Urban Design Observations

Application ref: DM/26/0131

Address: Land South And West Of Upper Imberhorne School Imberhorne Lane East
Grinstead West Sussex

Description: Approval of Reserved Matters following Outline Planning Permission (Ref. DM/23/2699) relating to appearance, landscaping, layout and scale for 550no. new residential units.

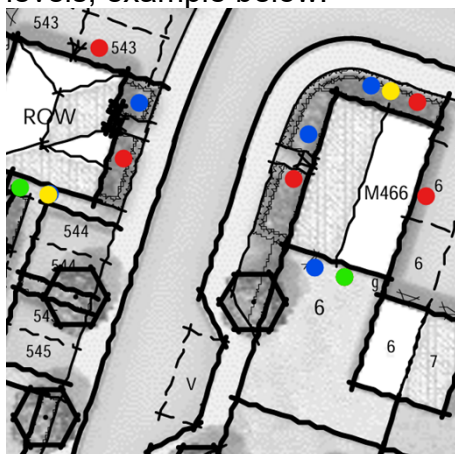
- There currently appears to be a complete lack of connection between the north and south sides of the main spine road along its entire length. To address this, explore introducing raised crosswalks, curb extensions, median refuge islands, tightening of the corner radius at the junctions, pedestrian crossings combined with surface and material enhancements, such as textured pavement (e.g., cobblestone or brick intersections), coloured crosswalks

- Mixed-used area, primary school and the central open space forms triangle of strong desire lines. It's particularly important to support pedestrian movement in this zone though the design and slowing down the traffic. Introduce passive (self-enforcing) traffic-calming design. Use geometry (lane shift, lane narrowing, pedestrian refuge island), surface treatment, and visual cues so drivers naturally slow down without relying on enforcement. Introduce raised crossings, contrasting pavement zones to clearly define pedestrian areas, bollards to reinforce pedestrian edge, surface and material enhancements, such as textured pavement (e.g., cobblestone or brick intersections), coloured crosswalks etc.

These measures will improve safety, slow down traffic, reduce traffic noise, and enhance accessibility across the spine road.

- Some other pedestrian crossings/links also need to be explained in more detail (see marked zone below).
